Work Order ID 94105

Item Name: Replacement Skidtube

DRAWING NO. D3804	TITLE SKIDTUBE ASSEMBLIES, 206A/B	REV. A	<b>DART AEROSPACE LTD ENGINEERING ORDER</b>		D.E.O. NO. D3804-A-1	SHEET NO. SHEET 1 OF 1	SCALE NTS
DRAWN <i>CP</i>	CHECKED <i>AP</i>	MFG. APPR. <i>[Signature]</i>	APPROVED <i>[Signature]</i>		DE APPR. <i>[Signature]</i>		
DATE 12.10.12	DATE 12.10.22	DATE 12.10.22	DATE 12.10.22		DATE 12.10.22

CHANGE C'BORED WELDED CROSSBOLT SPACERS TO SWAGED SPACERS

**CHANGE:**

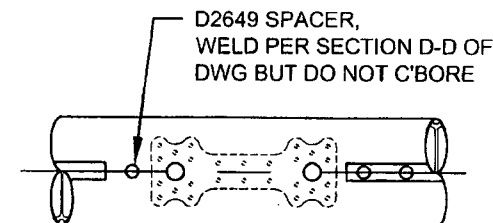
PARTS LIST IS AMENDED AS FOLLOWS:

QTY	QTY	PART NUMBER	DESCRIPTION
-041	-043		
1	1	D2649	CROSS BOLT SPACER
18	19	D4720-1	SPACER

**DETAIL B**

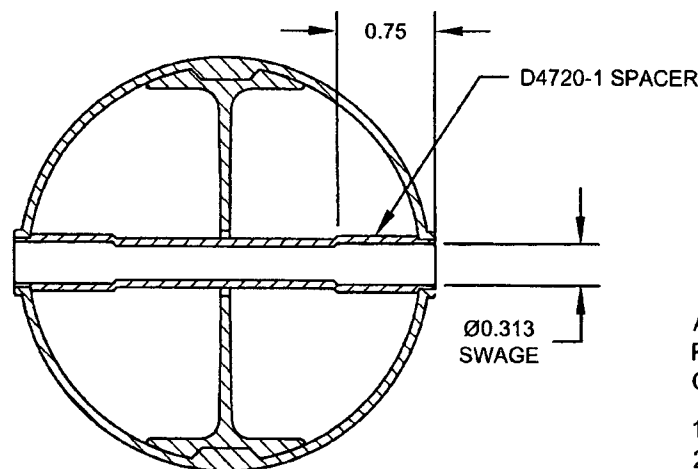
ADD SECTION H-H BELOW, WHICH IS THE SAME SECTION VIEW AS SECTION D-D OF DWG.  
**C'BORED** HOLES ARE **NOW SWAGED** PER SECTION H-H BELOW. FOR THE Ø0.375 HOLE THAT IS NOT C'BORED, WELD PER SECTION D-D OF DWG (SEE AMENDED DETAIL B FOR REFERENCE).

AMENDMENT TO DETAIL B  
NOT TO SCALE
